# BRIDGECOR STEEL BOX STERLING RANCH ROAD- CO SPRINGS COLORADO SPRINGS, CO

CDR-22-006

BRIDGECOR STEEL BOX  
38'-1" SPAN X 11'-11" RISE  
STERLING RANCH ROAD- CO SPRINGS  
COLORADO SPRINGS, CO

**STRUCTURE CROSS-SECTION**

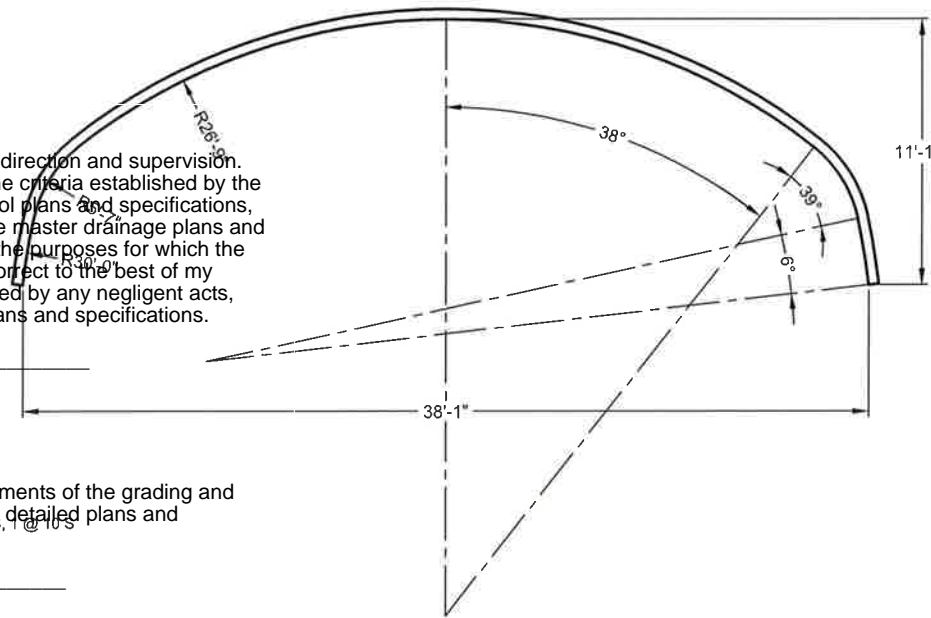
Provide standard signature blocks
